Addendum # 1 to Bid # 200001-05
For
Oregon Department of Corrections
Coffee Creek Correctional Facility Expansion Project

CCCCF Expansion's Technical Specifications and Drawings are revised as follows

SS03 TYPICAL MINIMUM HOUSING CONTROL PANEL

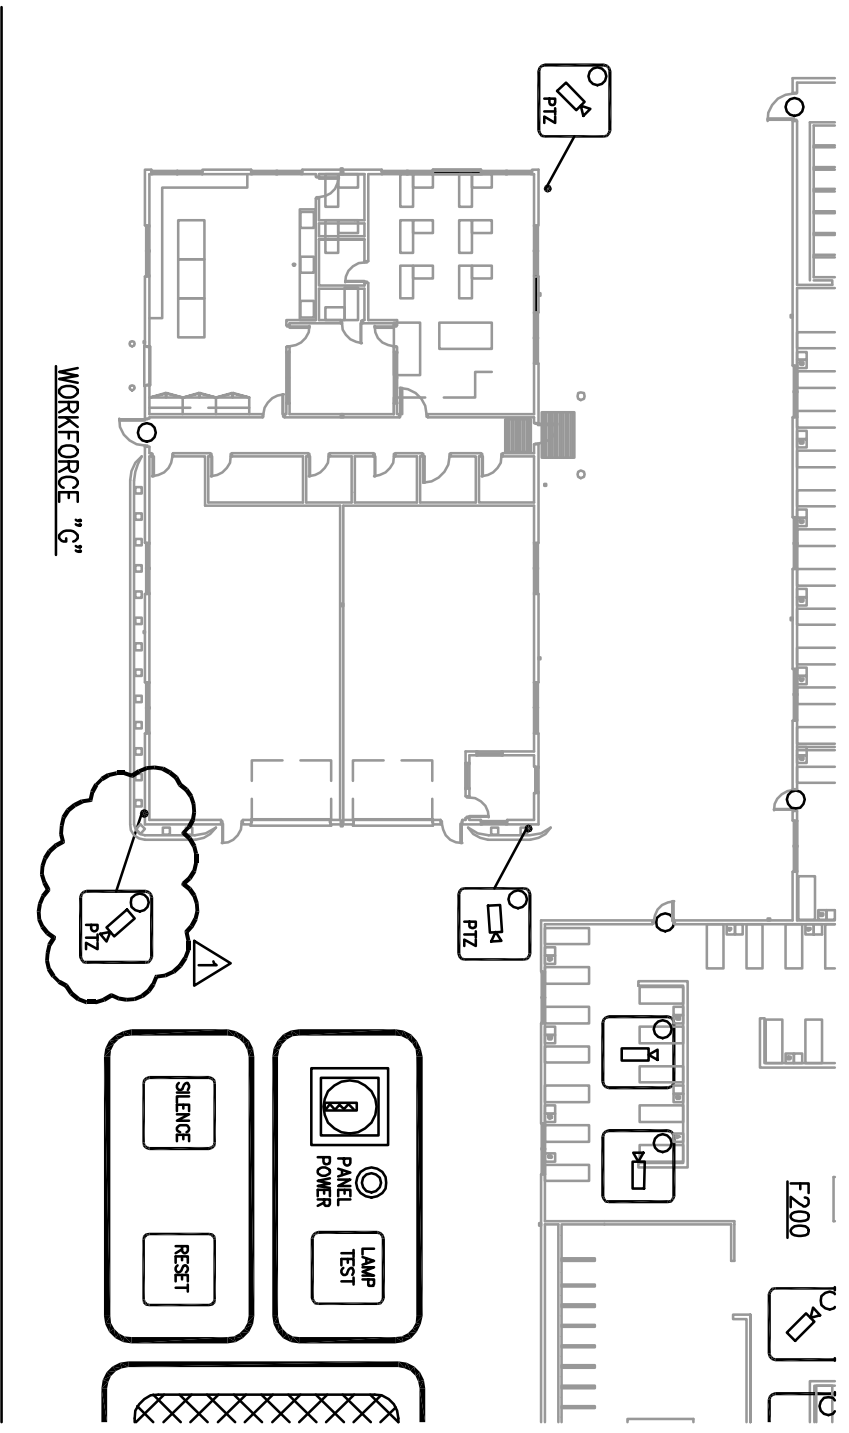
A. Add control switch for added Camera on building G as shown on attachment SS03
